Dart Aerospace Ltd.

## Process Sheet

<b>Customer</b> :	CU-DAR001 Dart Helicopters Services	<b>Drawing Name</b> :	SKID TUBE ASSEMBLY
<b>Job Number</b> :	42893A		
<b>Estimate Number</b> :	12520		
<b>P.O. Number</b> :		<b>Part Number</b> :	D205634045
<b>This Issue</b> :	23/10/2008	<b>S.O. No.</b> :	
<b>Prsht Rev.</b> :	NC	<b>Drawing Number</b> :	D2580 REV D
<b>First Issue</b> :	1/1	<b>Project Number</b> :	N/A
<b>Previous Run</b> :	42892A	<b>Drawing Revision</b> :	D
	<b>Type</b> :	<b>Material</b> :	
	SKIDTUBES	<b>Due Date</b> :	01/02/2009
<b>Written By</b> :		<b>Qty:</b>	1
<b>Checked &amp; Approved By</b> :	JULIO 08.10.23	<b>Um:</b>	Each
<b>Comment</b> :	Est Rev:C Revised Steps 06-09-06 JLM Est Rev:D Added SS Wearplates & Gaskets 07-07-09 JLM

AMEND DRAWING D2580 REV. C TO ADD D2580-045 ASSEMBLY

DESIGN RF	DRAWN BY RF	DART AEROSPACE LTD HAWKESBURY, ONTARIO, CANADA	
CHECKED #	APPROVED #	DRAWING NO. DEO 9183	REV. B SHEET 1 OF 1
DATE 00.05.15		TITLE ADD SKIDTUBE P/N D2580-045	SCALE NTS
A	00.03.29	NEW ISSUE	
B	00.05.15	39.580 WAS 39.620

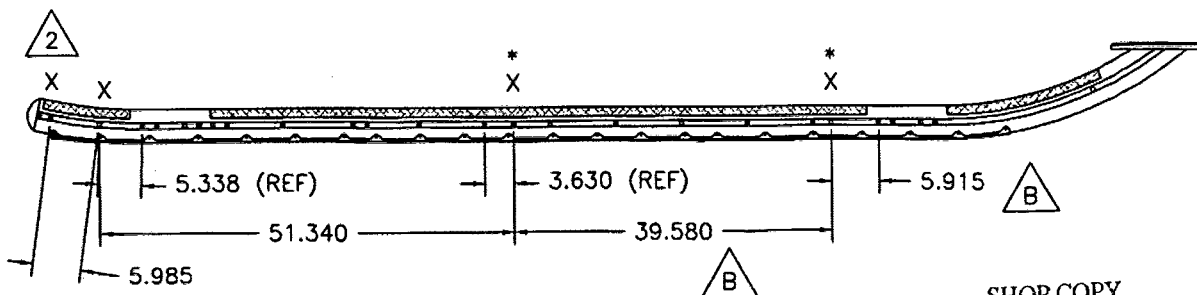
D2580-045 IS IDENTICAL TO D2580-041, EXCEPT FOR THE FOLLOWING CHANGES:

- 1) INSTALL CROSS BOLT SPACERS AT LOCATIONS MARKED 'X' ACCORDING TO THE FOLLOWING PROCEDURE.
  - a) DRILL  $\varnothing 0.508$  HOLES AT LOCATIONS SHOWN BELOW MARKED 'X'. CHAMFER HOLES  $0.030 \times 45^\circ$ . NOTE THAT HOLES WILL ALSO HAVE TO BE TRANSFERRED TO THE D2596 WEB AT THE \* LOCATIONS. IT IS ACCEPTABLE TO PRE-DRILL THE D2596 WEB IN THESE LOCATIONS BEFORE INSTALLING THE WEB IN THE SKIDTUBE. OPEN HOLES TO  $\varnothing 0.63$  AND TOUCH UP WITH ALODINE PER QSI 005 4.1.

- b) INSERT D2579 CROSS BOLT SPACERS INTO THE HOLES.
  - c) WELD INTO PLACE PER DART QSI 004 AND GRIND FLUSH.
  - d) REMOVE SPILL OVER LEAVING HOLE DIMENSION  $\varnothing 0.380$ - $\varnothing 0.390$ .

- 2) IT IS ACCEPTABLE TO GRIND A RELIEF IN THE D2855 AFT CAP TO PREVENT INTERFERENCE WITH THE SPACER AT THIS LOCATION.
- 3) POWDER COAT ENTIRE ASSEMBLY GREEN (REF. 4.3.5.8) PER DART QSI 005 4.3 INSTEAD OF WHITE (REF. 4.3.5.1).

**D2580-045 ASSEMBLY DETAIL**

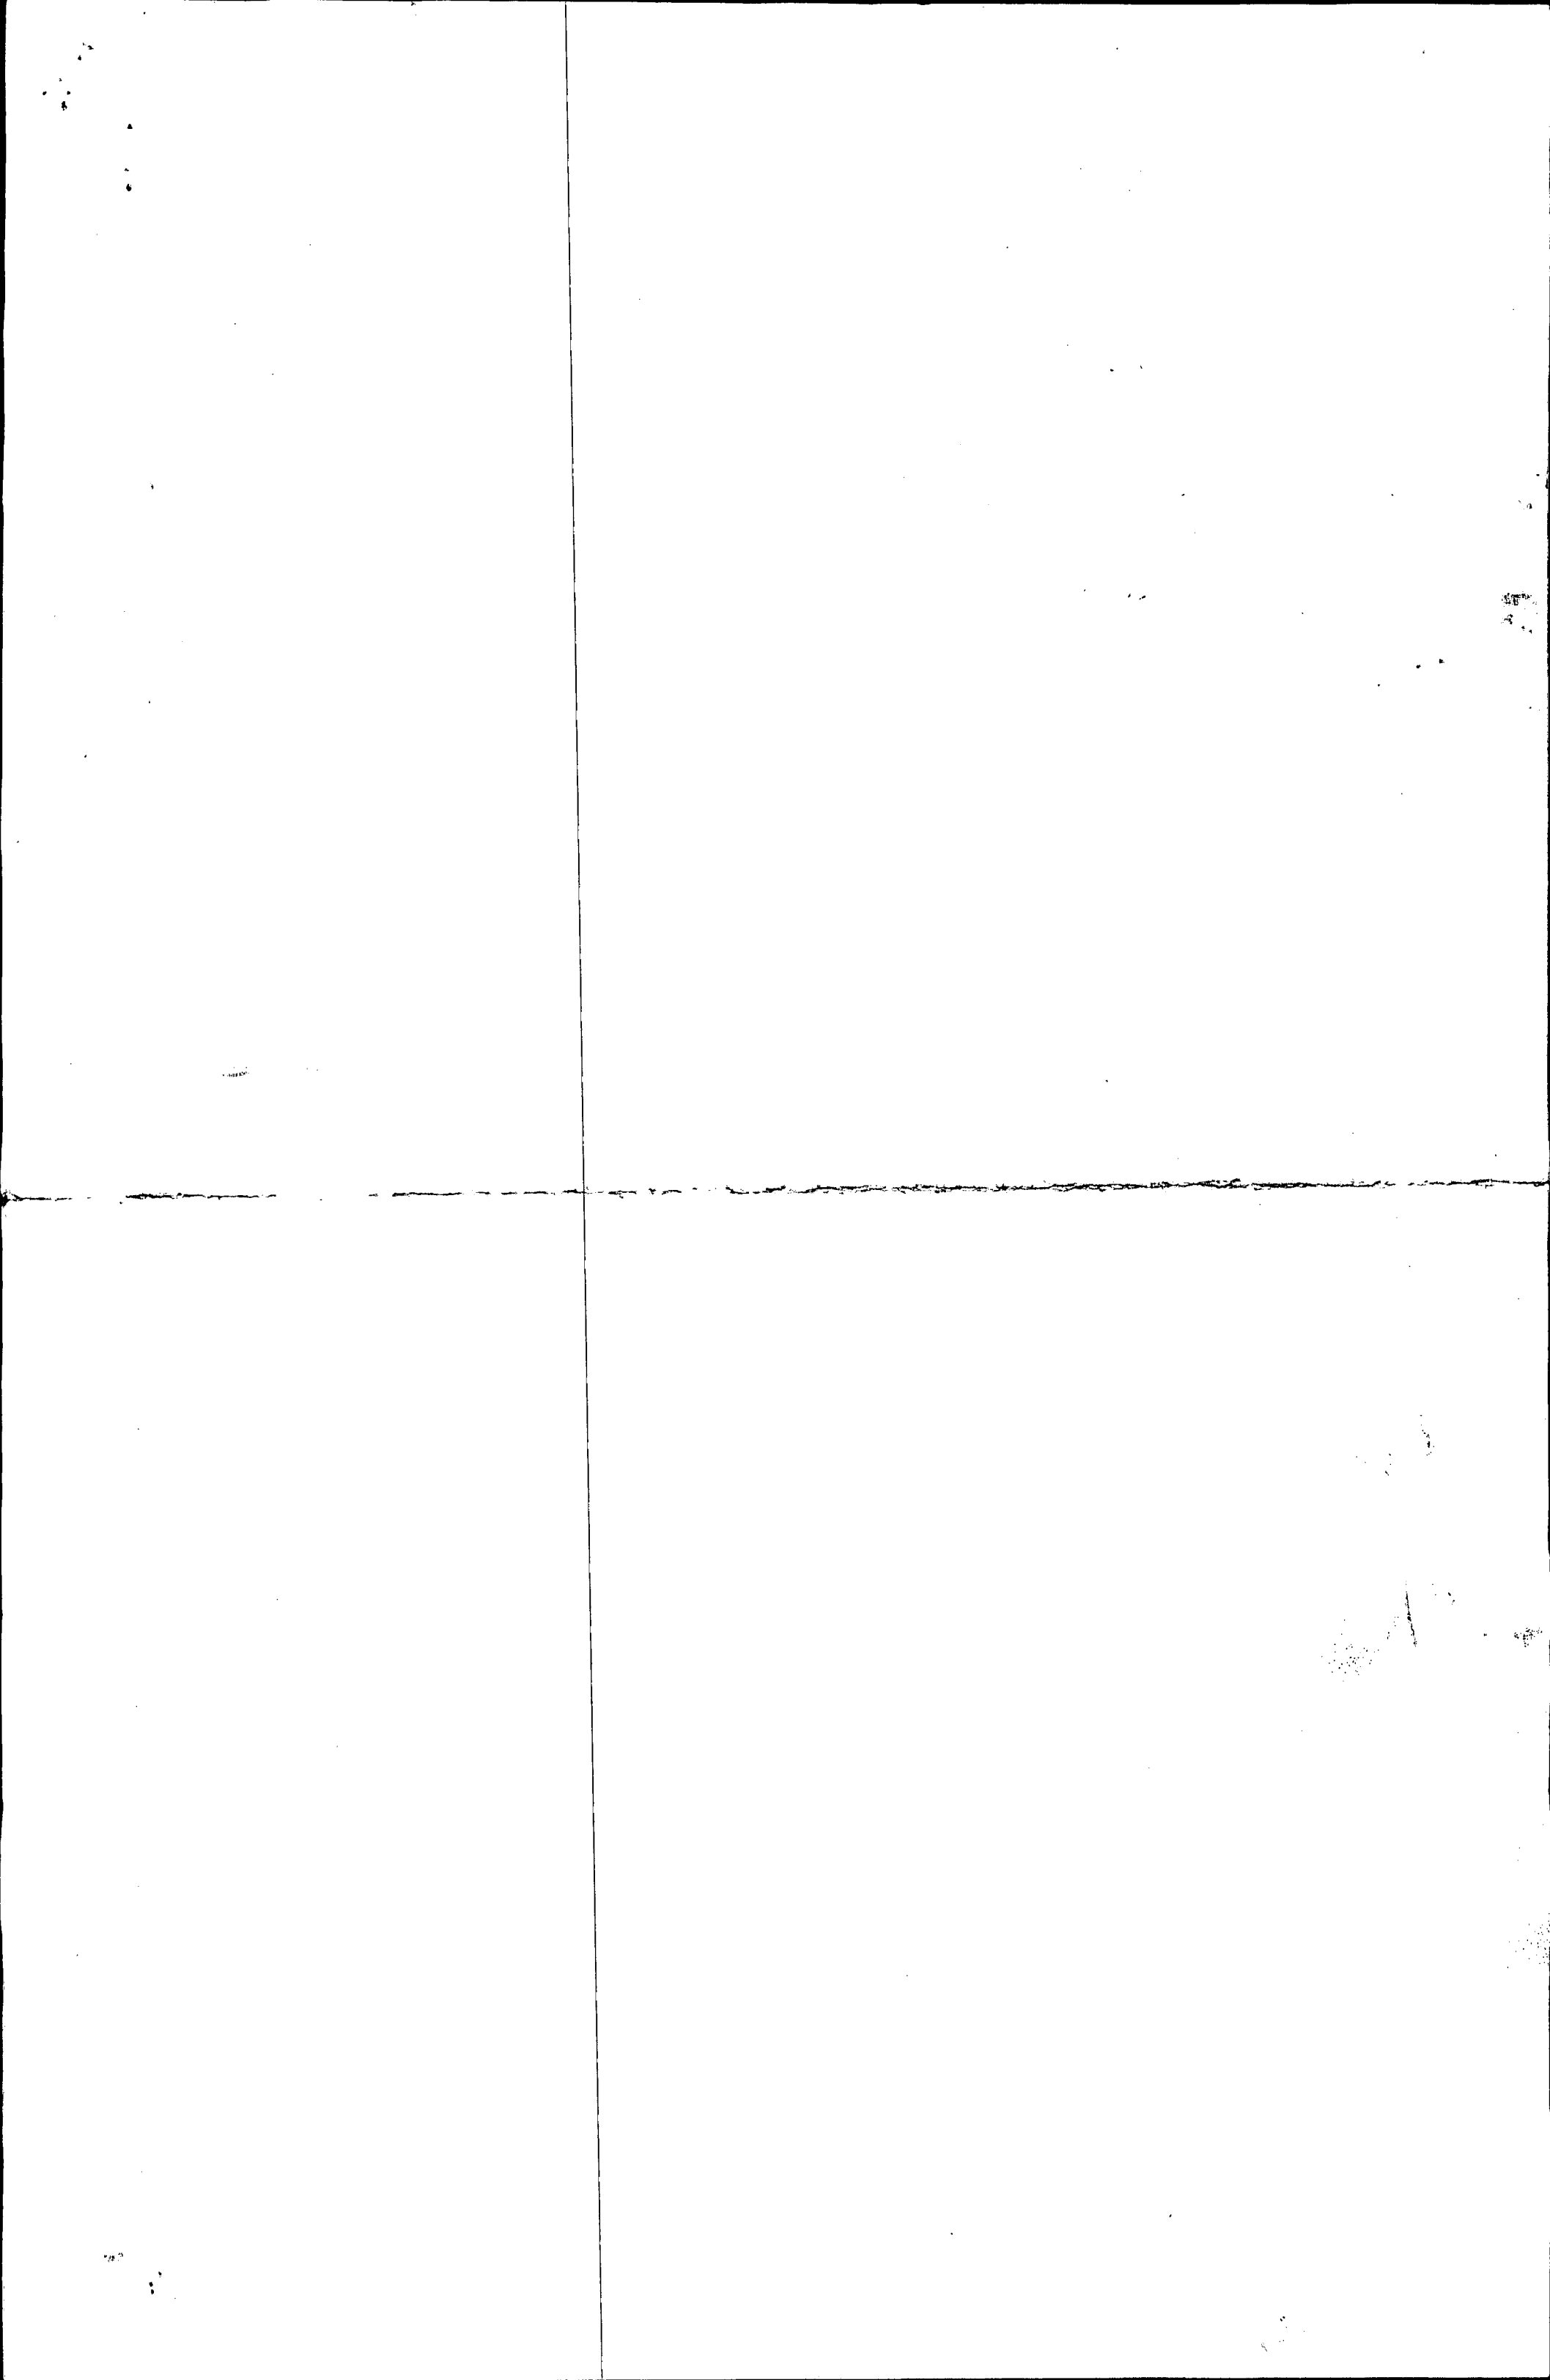
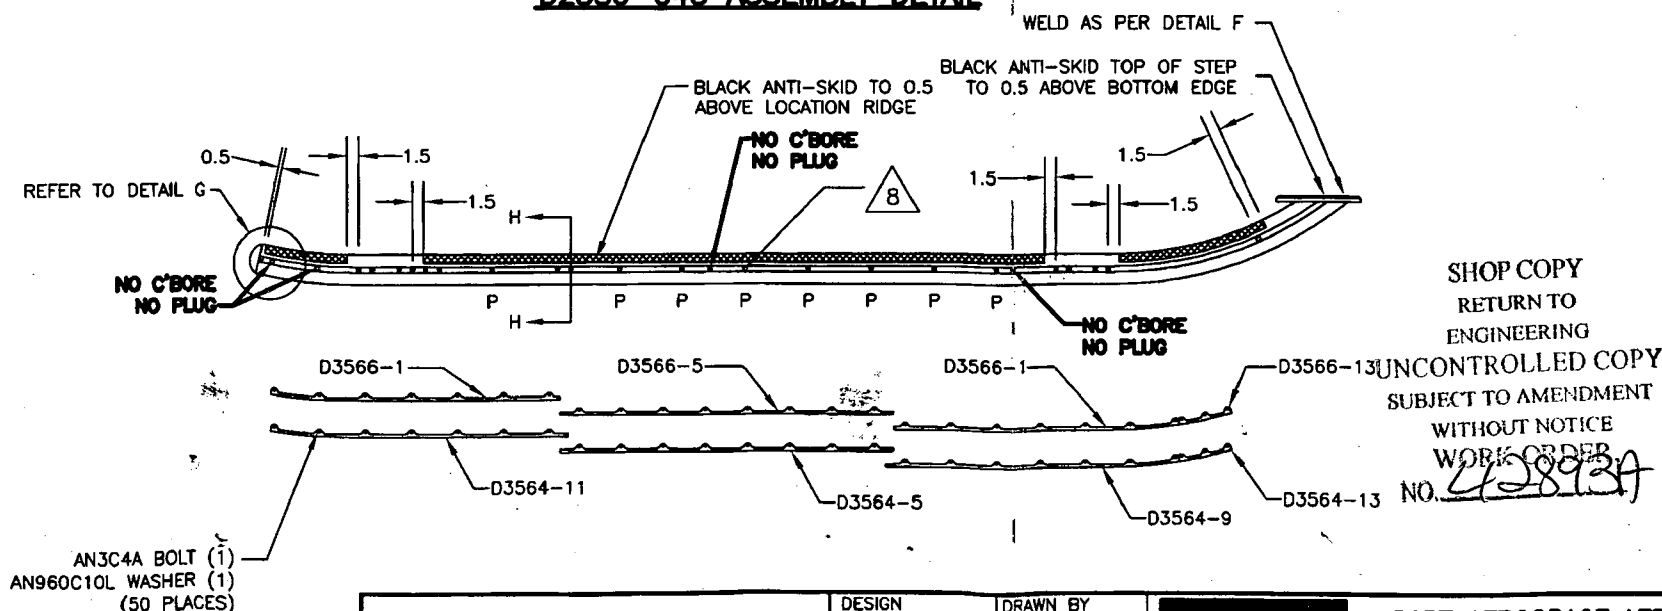
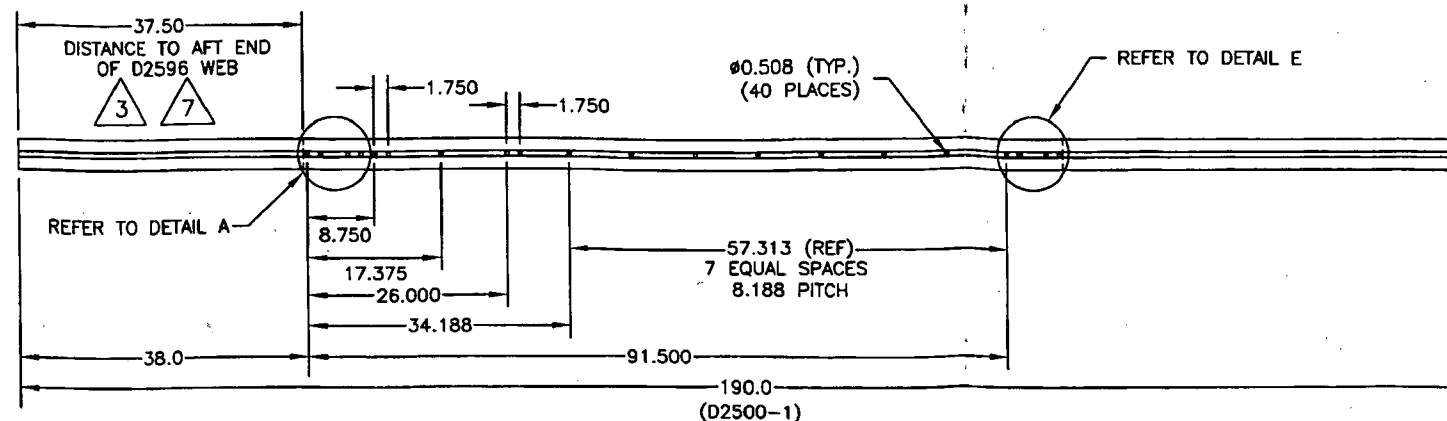
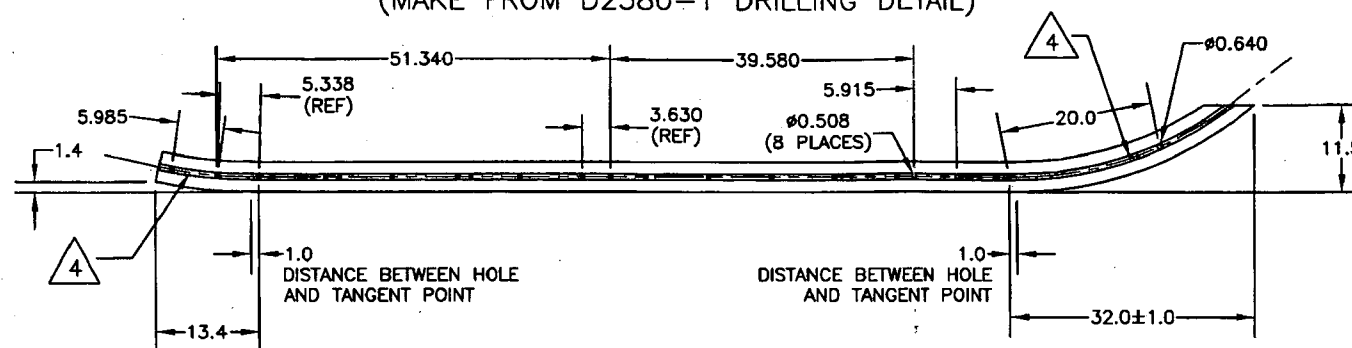
- FINISH: ACID ETCH, ALODINE PER DART QSI 005 4.1 PRIOR TO INSERTING D2596 WEB POWDER COAT ENTIRE ASSEMBLY GREEN (REF. 4.3.5.8) PER DART QSI 005 4.3 BLACK ANTI-SKID PAINT AS INDICATED PER DART QSI 005 4.4
- IT IS ACCEPTABLE TO GRIND A RELIEF IN THE D2855 AFT CAP TO PREVENT INTERFERENCE WITH THE SPACER AT THIS LOCATION
